Front Roof Console Needs to be Replaced – Observe Specified Procedure (101/21)

Model Line: **Panamera (971)**

Model Year: **As of 2017**

Concerns: **Front roof console needs to be replaced**

New roof console

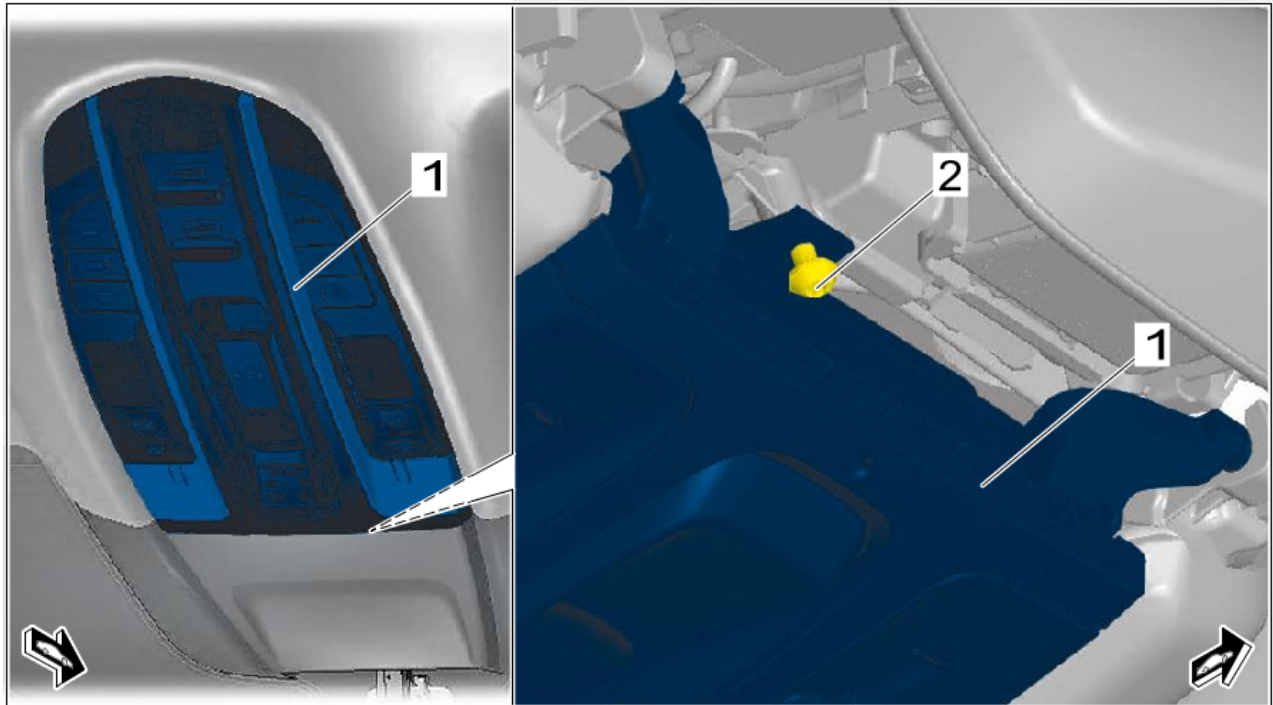
Information: Modified roof consoles that are secured to the roof lining with an additional threaded connection are installed in Panamera vehicles from model year M (2021).

The new roof console can be identified by a lug at the front. On vehicles from model year 2021, the roof console is screwed to the roof lining using this lug as well as the retaining clips.

- 1 – **New** roof console
- 2 – **New** threaded connection on roof console

Roof console engagement pins

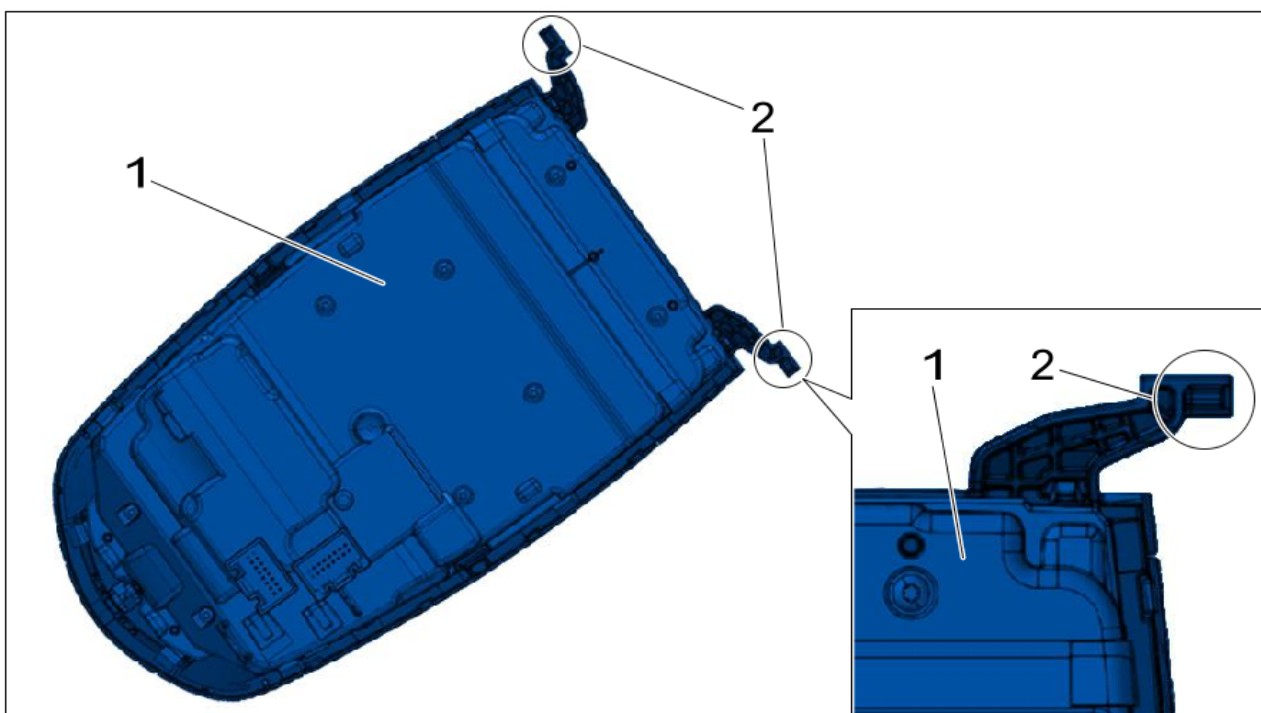
On old-type roof consoles (without the additional lug), the engagement pins have a smaller diameter than those used on the technically modified roof consoles. To ensure that the old-type roof console is installed without play in a new roof lining, the engagement pins of the roof console require subsequent work.

- 2.1 Cut each of the felt strips to **45 mm/ 1.77 in long and 7.5 mm/ 0.3 in wide**.
- 2.2 Wrap the felt strips you have cut **twice** around the engagement pins ⇒ *Roof console engagement pins -2-* of the **new** roof console ⇒ *Roof console engagement pins -1-*.
- 3 Install **new** roof console.
⇒ *Workshop Manual '708319 Removing and installing front roof console'*

New roof console

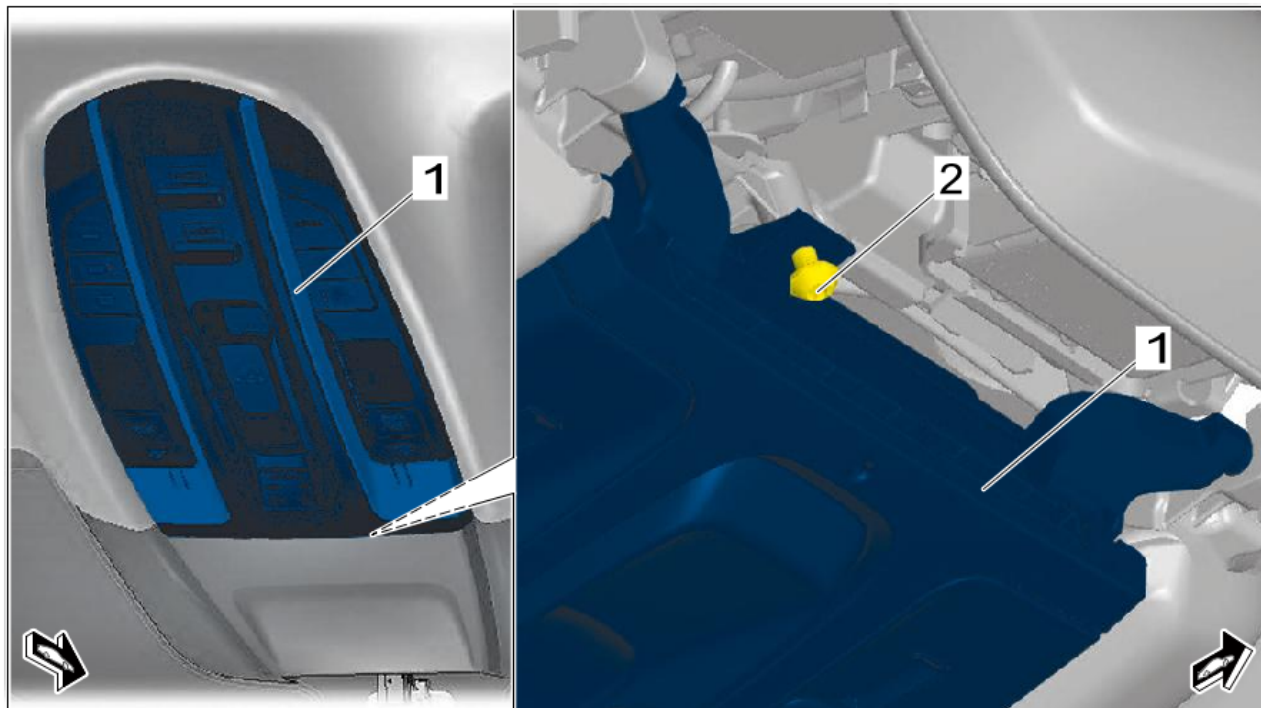
A technically modified roof console (with lug) may only be retrofitted in a model year 2017 to 2020 vehicle if there is **no** SOS button installed in the roof console.

An additional threaded connection to the roof lining was used on the new roof console. If you are installing a **new** roof console in a model year 2017 to 2020 vehicle, the threaded connection can be ignored and the roof console can be installed in accordance with instructions in the Workshop Manual.

- 1 – **New** roof console
- 2 – **New** threaded connection on roof console
